U.S. Department  
of Transportation  
**Federal Highway  
Administration**

In Reply Refer To:  
HSSD/SS-147

Thank you for your correspondence via an e-mail of March 21, 2007 requesting the Federal Highway Administration's (FHWA) acceptance of the U-channel post mounted to a perforated square steel tube that is inserted into a permanent base as a breakaway small sign support on the National Highway System (NHS). Accompanying your correspondence were drawings for the support and its foundation. You requested that we find the system acceptable based on observed field performance and by comparison to other breakaway supports under the provisions of National Cooperative Highway Research Program (NCHRP) Report 350 "Recommended Procedures for the Safety Performance Evaluation of Highway Features."

TYPE C SIGNS, DELINEATORS, & MARKERS IN CONCRETE

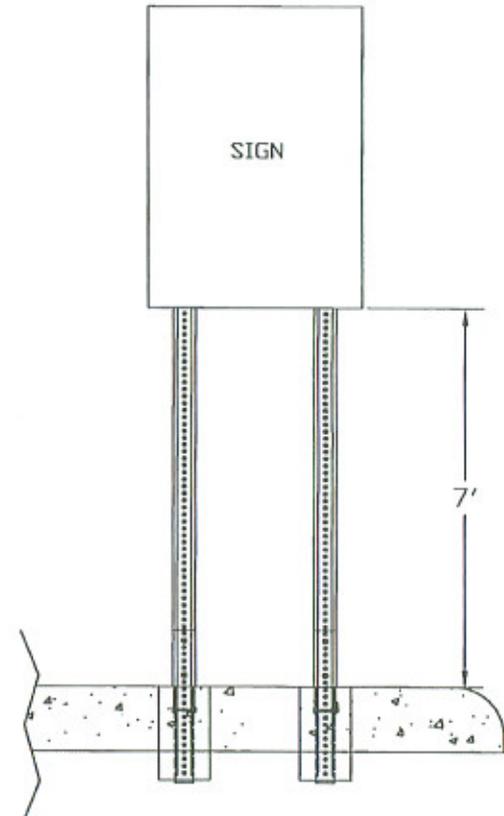
The following is a brief description of your generic design and detailed drawings are enclosed for reference. A standard 2-1/2 pound per foot U-channel post is bolted to a 12 inch long 1-3/4 inch perforated square steel tube (PSST) riser using two 5/16 inch Grade 5 bolts with locking nuts. The bolts should be spaced 4 inches apart and connected such that the U-channel is approximately one inch above the ground line. The PSST riser must fit snug as it is inserted at least 4 inches into the base that is securely held in a concrete footing (minimum 8 inches deep). The PSST riser projects 8 inches above the concrete.

Since perforated square steel supports mounted to U-channel posts have not been crash tested, it is not known if potential exists for the support or sign to penetrate the occupant compartment. In order to reduce that potential we recommend that the mounting height of the sign be, as a minimum, seven feet to the bottom of the sign. You also requested the installation of two posts within a seven foot path to be used to support a sign. We concur with this request as similar supports were also successfully tested with a dual post configuration.

The support described above and shown in the enclosed drawings for reference can be expected to meet the NCHRP Report 350 requirements and it may be considered acceptable for use as a test level 3 device when installed as shown in the attached drawing. Please note the following standard provisions, which apply to the FHWA letters of acceptance:

SLEEVE DETAIL/CONNECTION DETAIL

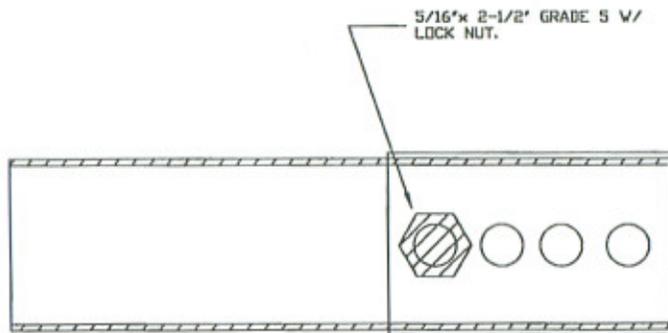
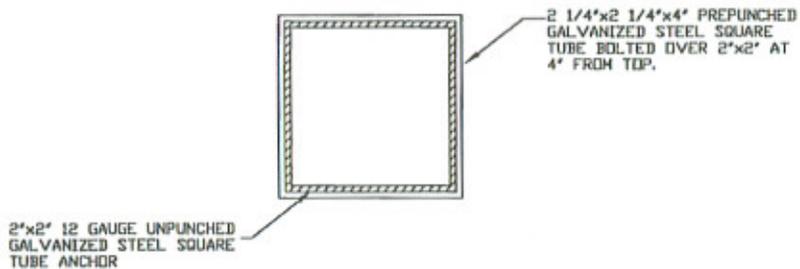
No crash testing of this support has been conducted. However, successful crash tests have been conducted on 1-3/4 inch PSST inserted into 2 inch PSST and securely bolted together near the ground line. The tested PSST support referenced in the FHWA acceptance letter SS-36 (design 92F039), is considered equivalent to your proposed design. Also, based on your observations of field performance, the 1-3/4 inches PSST riser consistently breaks at the ground line with no

remaining stub exceeding 4 inches. It is apparent that, in the event of an impact, the 1-3/4 inches PSST riser breaks at the ground line and it would be anticipated that the vehicle velocity change caused by your proposed generic design will be equivalent to that of the successfully tested support.
